***RE: Comments on EPA DEIR/LRC Responsiveness Summary***

**Review by the General Electric  
Company of the USEPA Responsiveness  
Summaries: DEIR and LRCR**

**December 2000**

Figure 1-2. The relative fate of PCBs leaving TIP cohesive sediments as computed by the USEPA HUDTOX model for the period from 1984 to 1994. Values are percentages of the total flux from cohesive sediments.

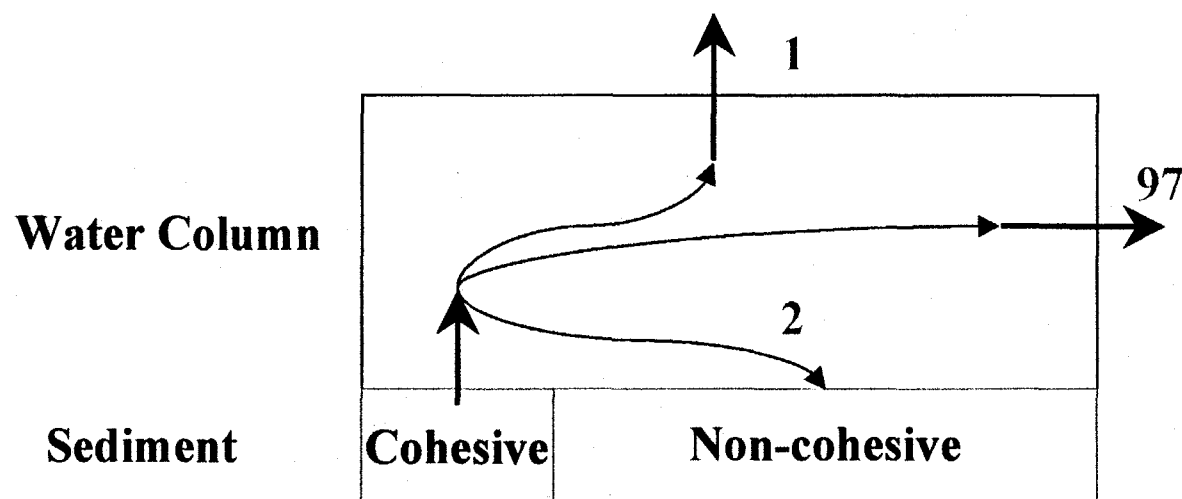
was substantially less than the amount claimed to have left the sediment. The USEPA response to that criticism was to claim that a significant portion of the PCBs that left the cohesive sediments were redistributed within the TIP (LRCR Responsiveness Summary). QEA evaluated this proposition by determining the extent of redistribution predicted by the USEPA model. Setting the upstream source and the non-cohesive sediment PCB level to zero in the HUDTOX model and monitoring the flux of PCBs into the non-cohesive sediments, we found that only 2 percent of the PCBs that leave the cohesive sediments are redistributed to the non-cohesive sediments (Figure 1- 2).

Figure 1-3. The relative contributions of the various PCB sources to the 1994 PCB flux at the Troy Dam as computed by the USEPA HUDTOX model.

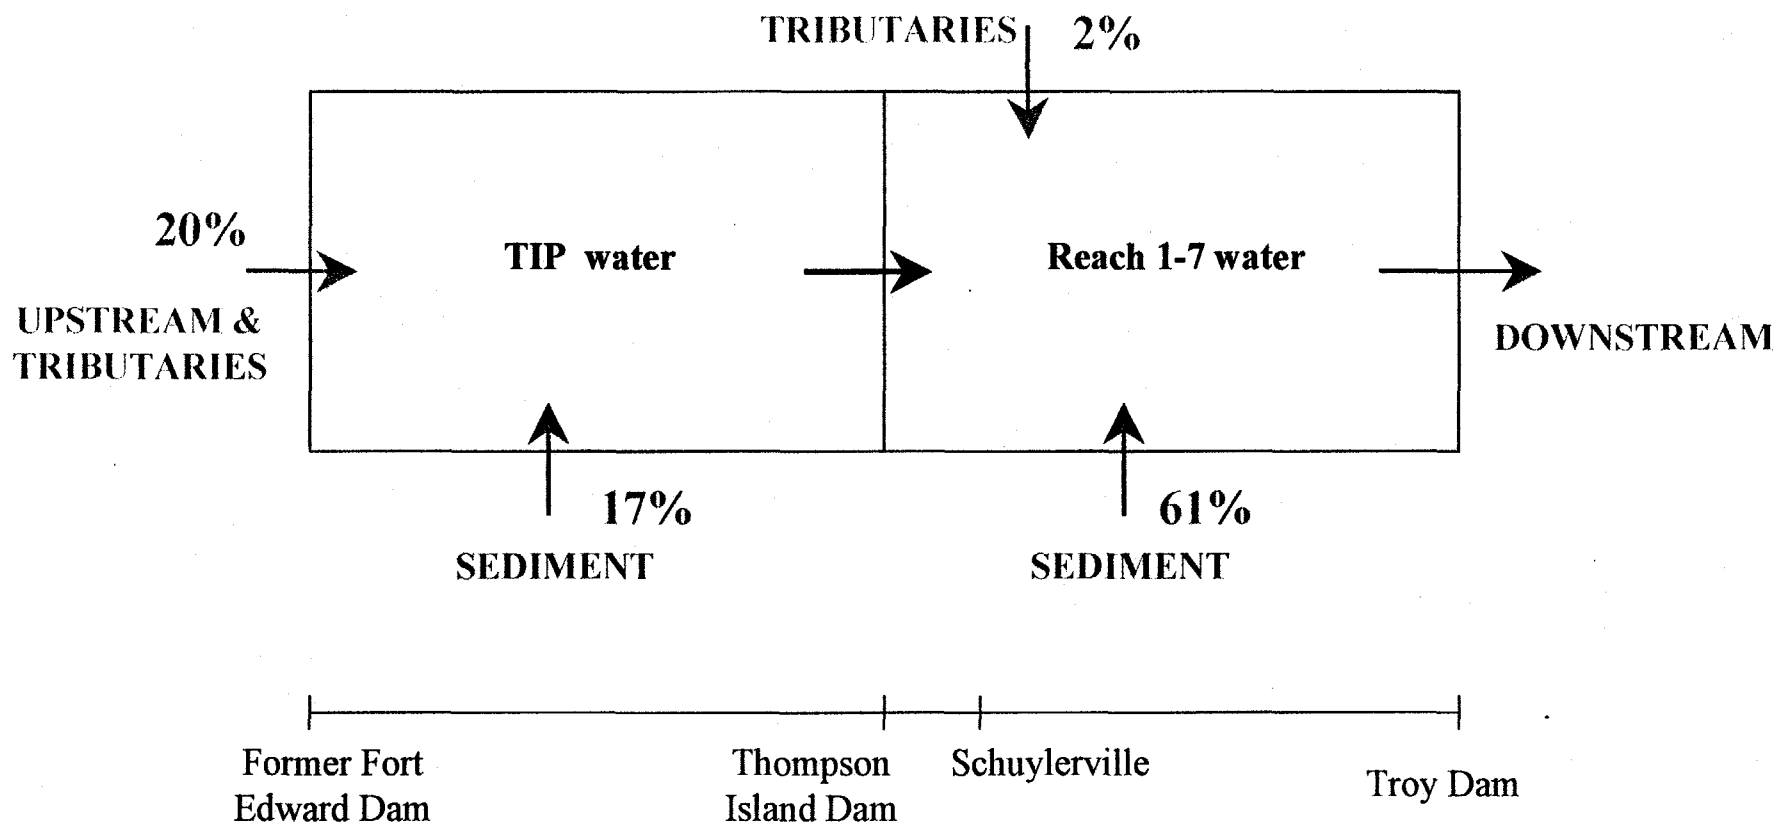
The importance of the downstream reaches is demonstrated by mass balance analyses QEA conducted with the USEPA HUDTOX model for 1994. These analyses indicate that only 17 percent of the PCB load at Troy originates from TIP sediments (Figure 1-3).

Figure 2-3. Comparison of PCB homolog distributions for Aroclor 1242 and calculated aqueous phase in equilibrium with Aroclor 1242.

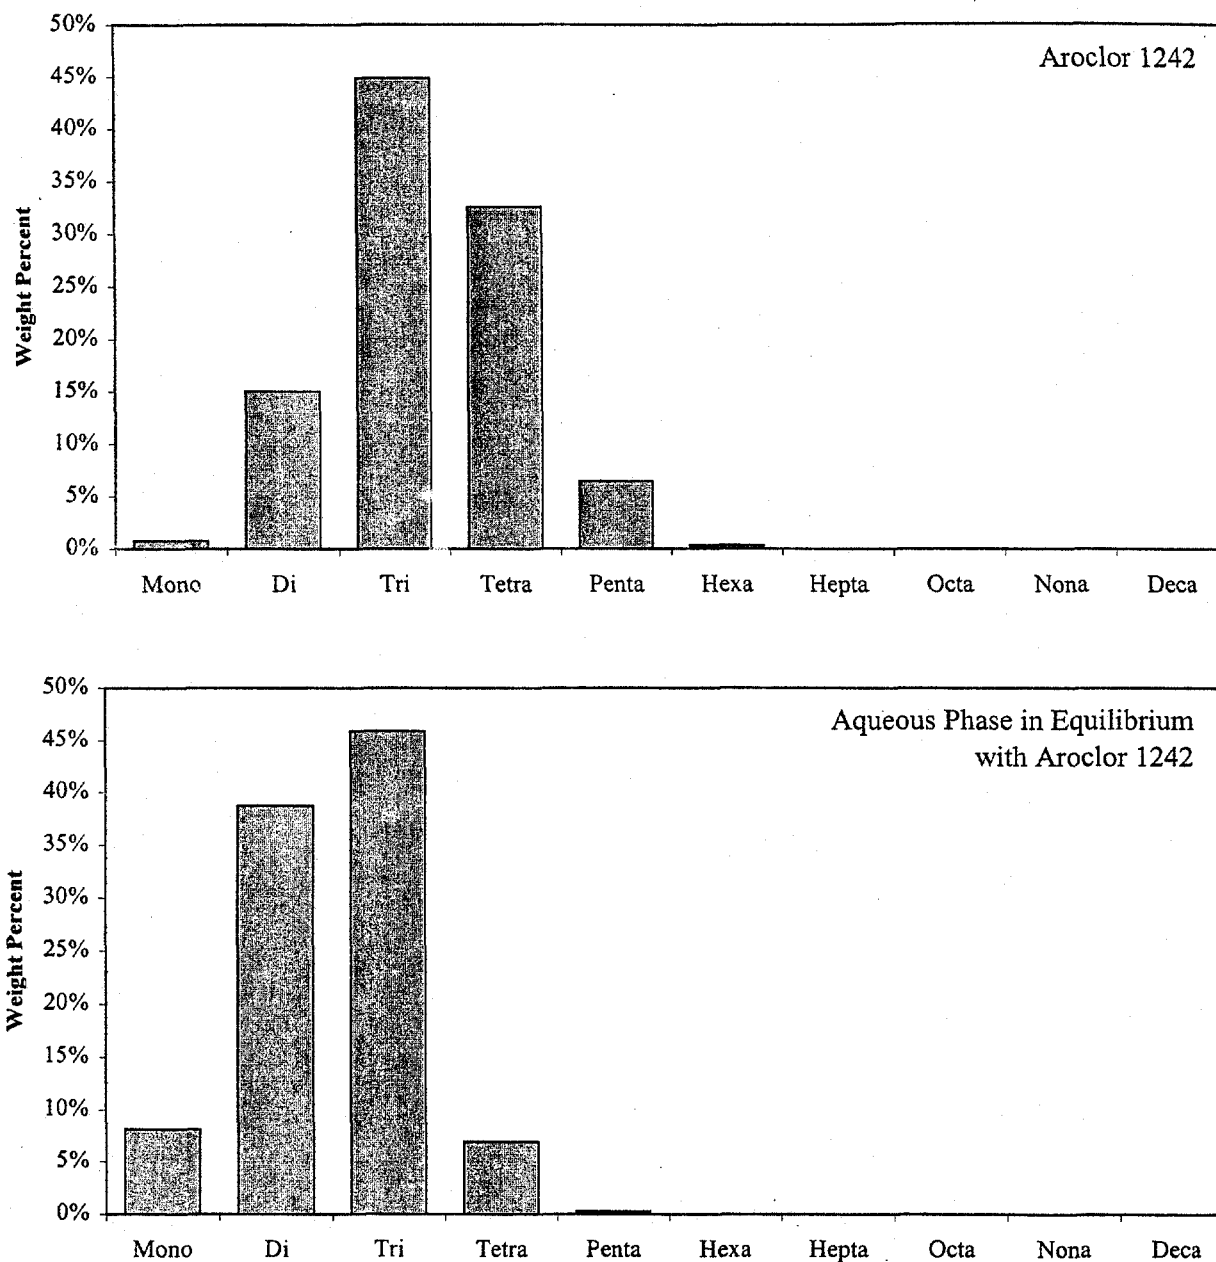
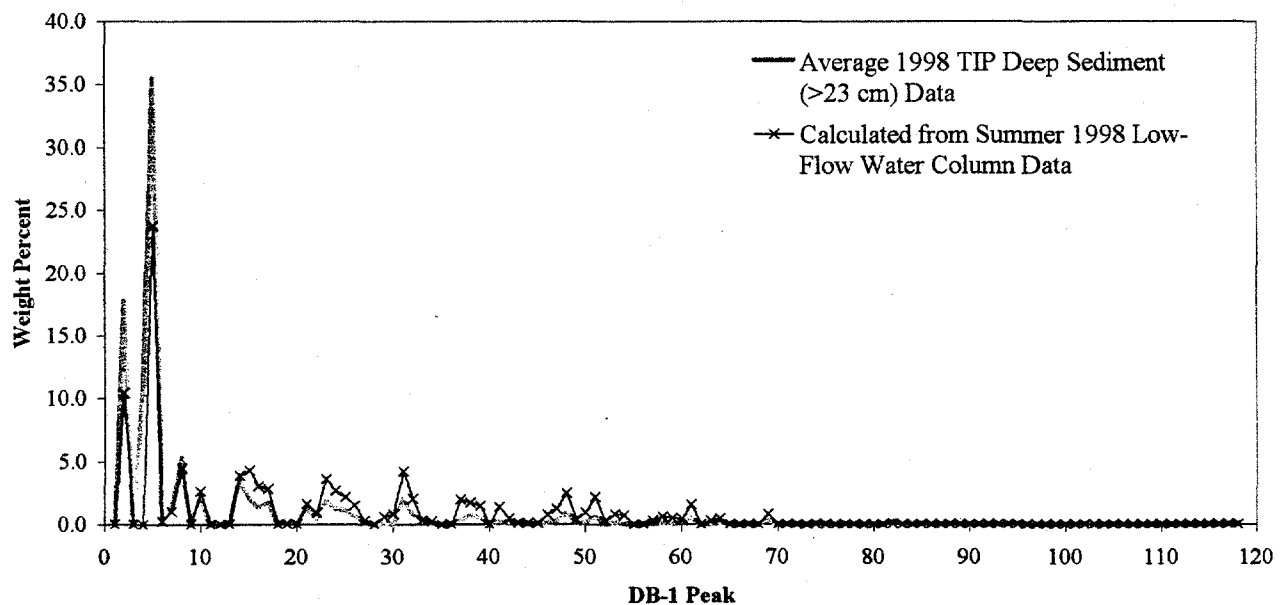
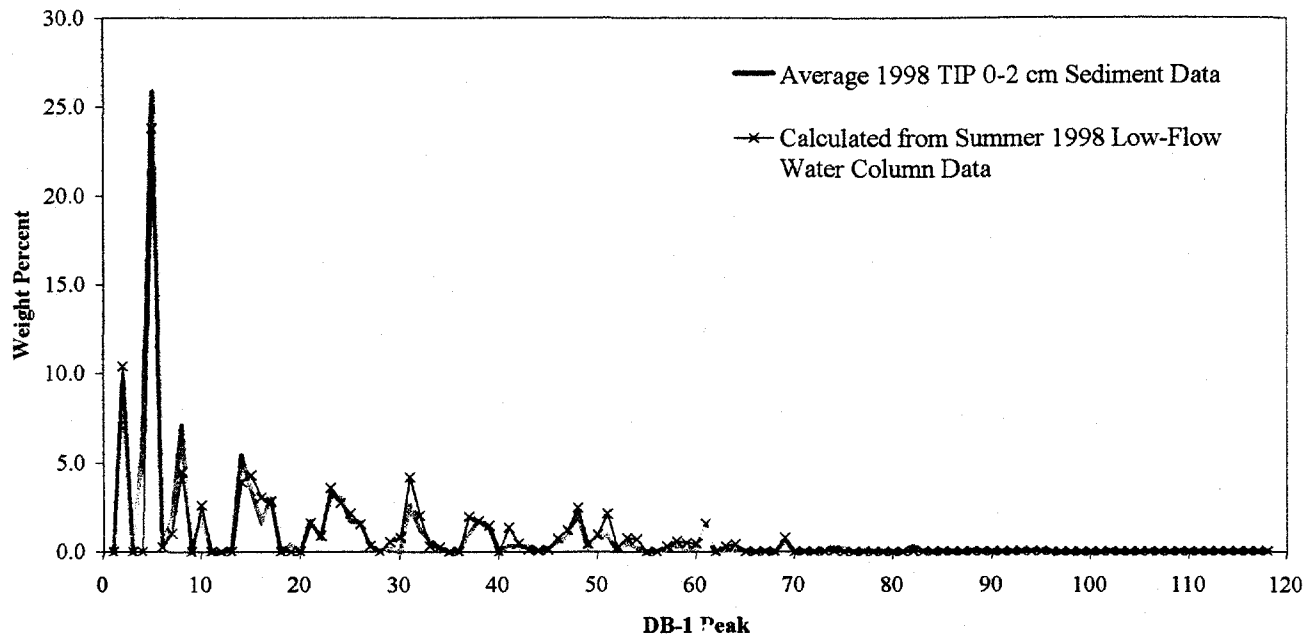
USEPA contrasted the summer 1997 water column load congener composition with that of Aroclor 1242. A better comparison would be one that considers water in equilibrium with Aroclor 1242. Due to established differences in congener partitioning, an Aroclor 1242 source would result in an aqueous-phase PCB composition enriched in the less chlorinated congeners (Figure 2-3).

**Figure 2-4.**

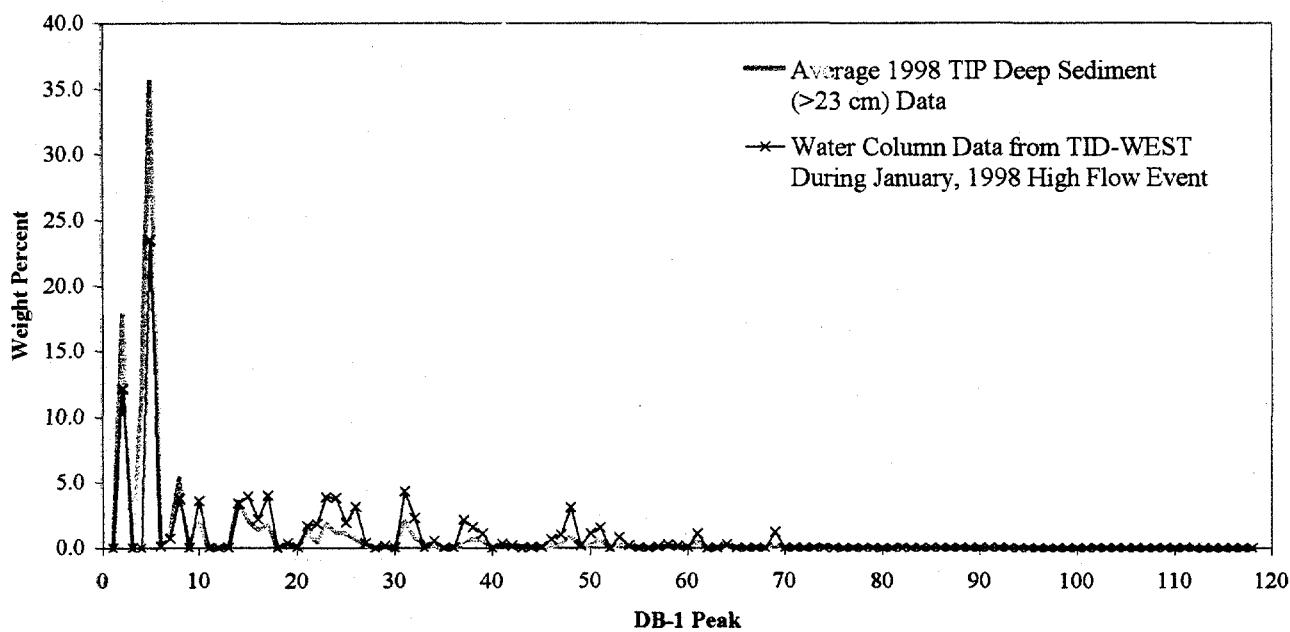
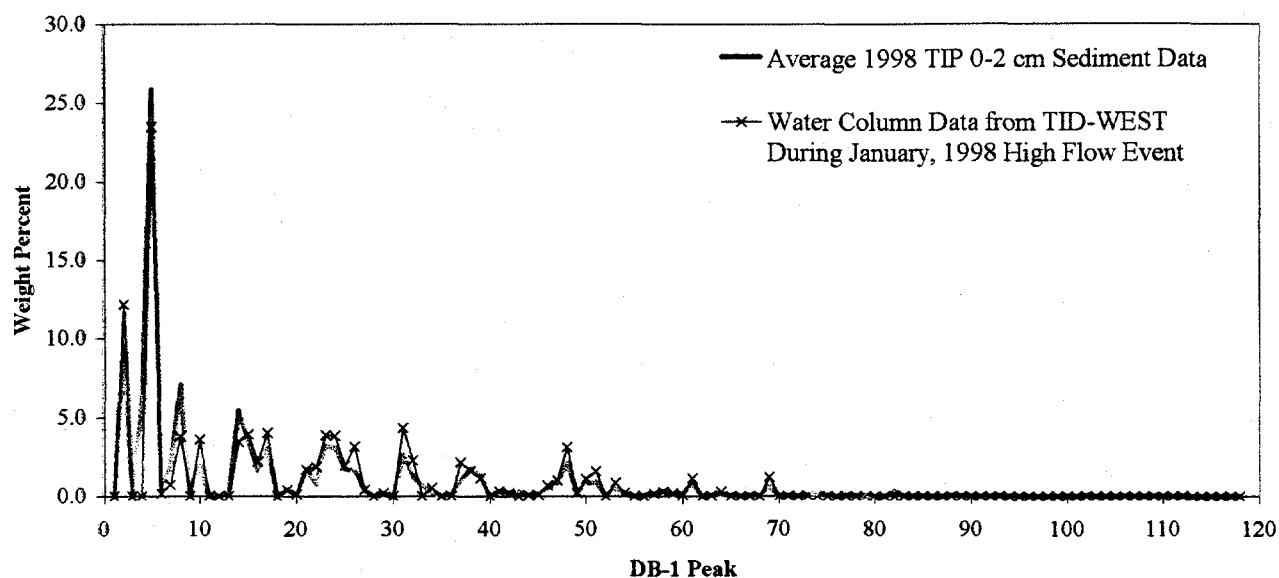
mechanism and equilibrium partitioning. This analysis results in almost an exact PCB congener composition match between the sediment source back-calculated from 1998 water column data and the average from the 1998 sediment data (Figure 2-4).

**Figure 2-5.**

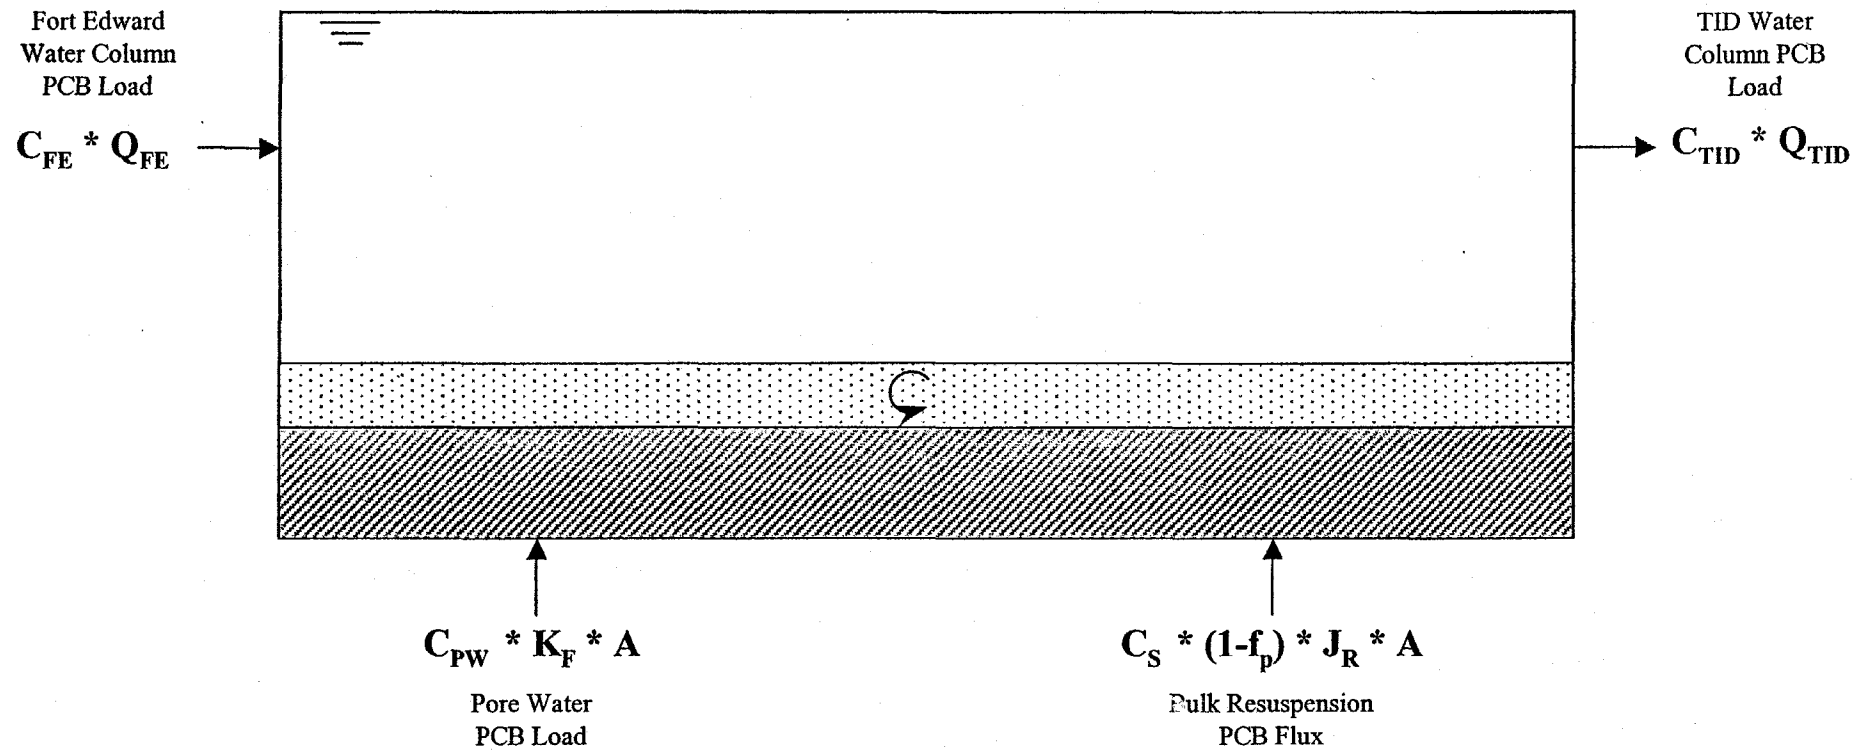
*Rebuttal:* USEPA's response re-emphasizes GE's point. If scour had been occurring at the magnitude implied by USEPA's conclusions in the LRCR, then the deeper sediment sources would have to be contributing to current water column PCB loadings. If this was the case, measured water column congener patterns would not be consistent with surface sediment sources. However, both GE and USEPA have shown that water column-derived PCBs in TIP are indeed consistent with surface sediment sources (see Section 2.4 of this document, Figures 2-4 and 2-5, and Butcher et al. 1998).

PCB data and not that of the deeper, more dechlorinated sediments (Figure 2-5). While it is true that the TIP load may consist of sediments of varying dechlorination status, the fact that the water column load is consistent with the *average* surface sediment composition indicates that the predominant source is the surficial layer not the deeper, more dechlorinated deposits, which have remained in-place.

Figure 2-7. Comparison of PCB congener composition for the average summer 1997-98 TIP delta load and a best fit loading calculated based on the sum of the loadings from pore water and bulk resuspension.

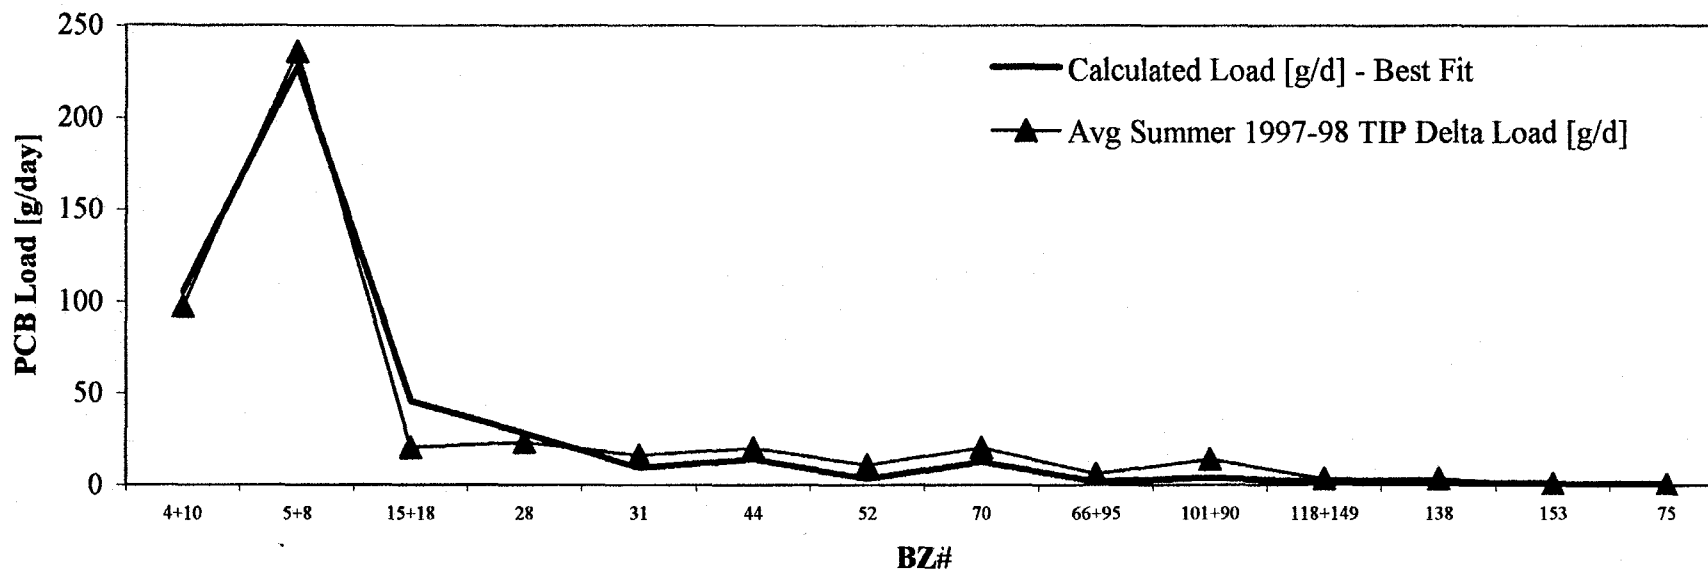
The analysis was conducted using the average summer 1997-98 low flow TIP congener water column loading for a comparison. The calculated sediment congener loading was based on the sum of the loadings from pore water and bulk resuspension, with the mass flux coefficients (*i.e.*,  $k_f$  and  $J_R$ ) adjusted such that the calculated load best matched the congener loadings derived from the water column data. The congener-specific parameters and results from this mass balance analysis are shown in Table 2-1 and are plotted in Figure 2-7.

As can be seen from Figure 2-7, the best fit of the combined mechanisms closely matches the 1997-98 water column data. The best fit coefficients from this analysis are a net pore water
